FINAL PLAT

R.T.I. ADDITION

Re: S/D 96-54 - R.T.I. ADDITION (Final Plat)

STAFF REPORT
(Final Plat Approved 8/22/96)

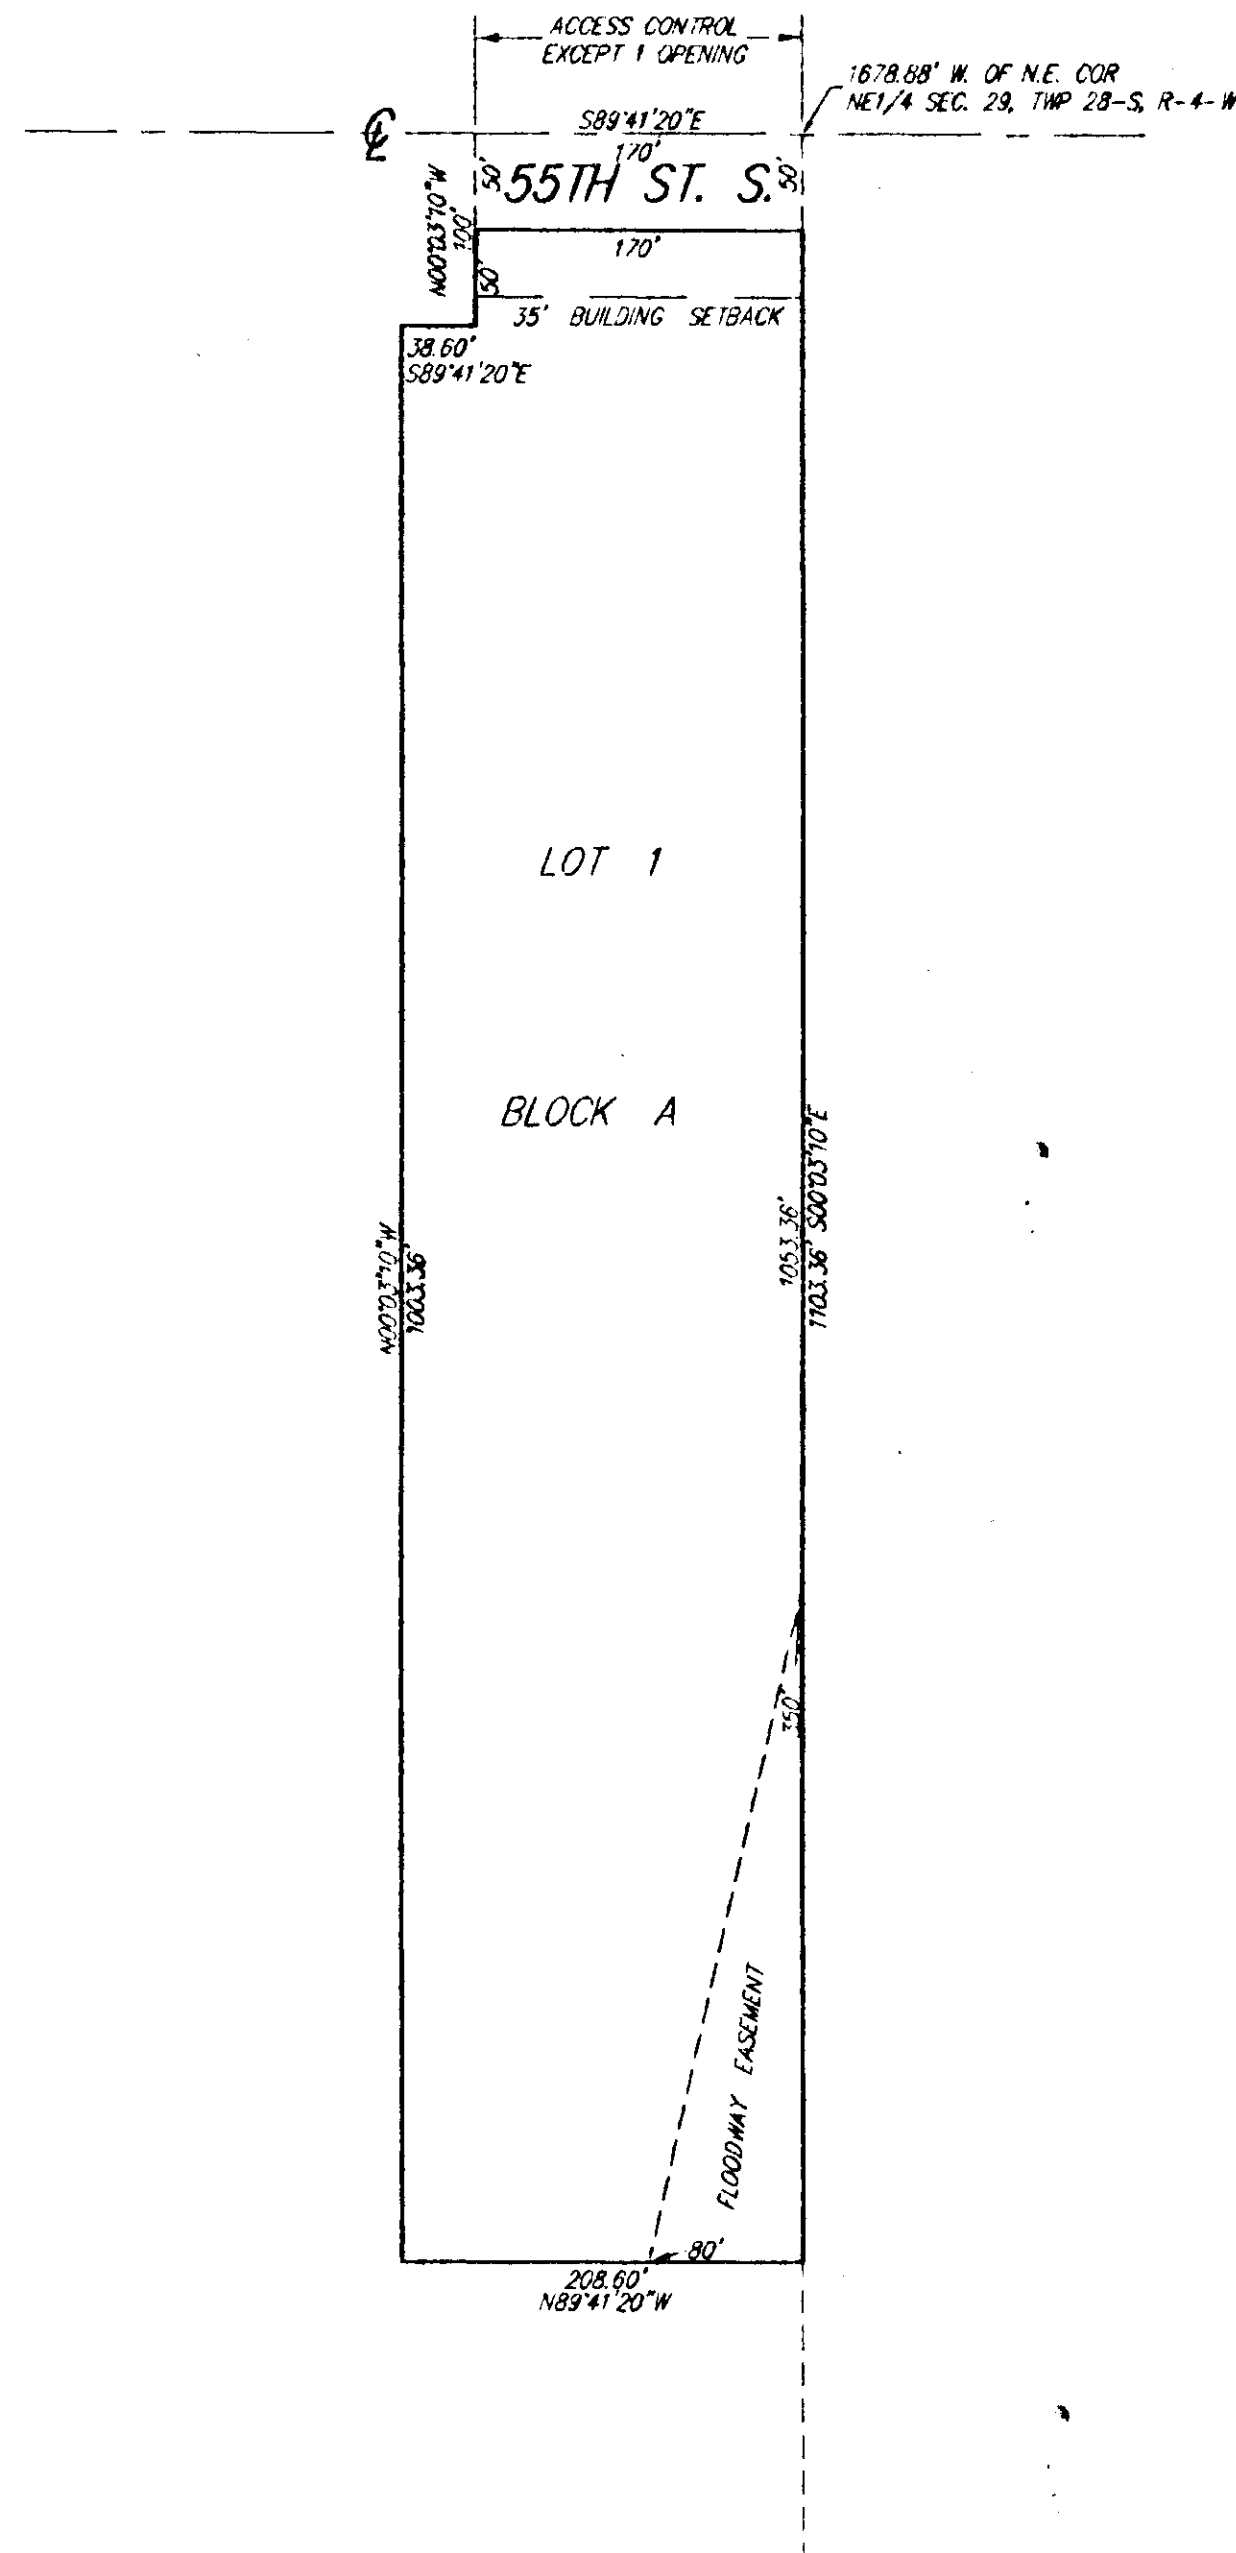
- B. The applicant shall guarantee any drainage improvements required by the platting of this property.
- C. Based on the existence of a floodway on this site, County Engineering is requiring a minimum building elevation of 1,343'. Such elevation shall be noted both in the plat's text and on the face of the plat. Also, both an on-site and off-site benchmark shall be shown.

- D. In regard to the floodway, County Engineering indicated the involved area of this lot should be shown as a Floodway Reserve.
- E. It should be noted that for non-residential lots, the lot depth to width standard of 2 1/2:1 does not apply.
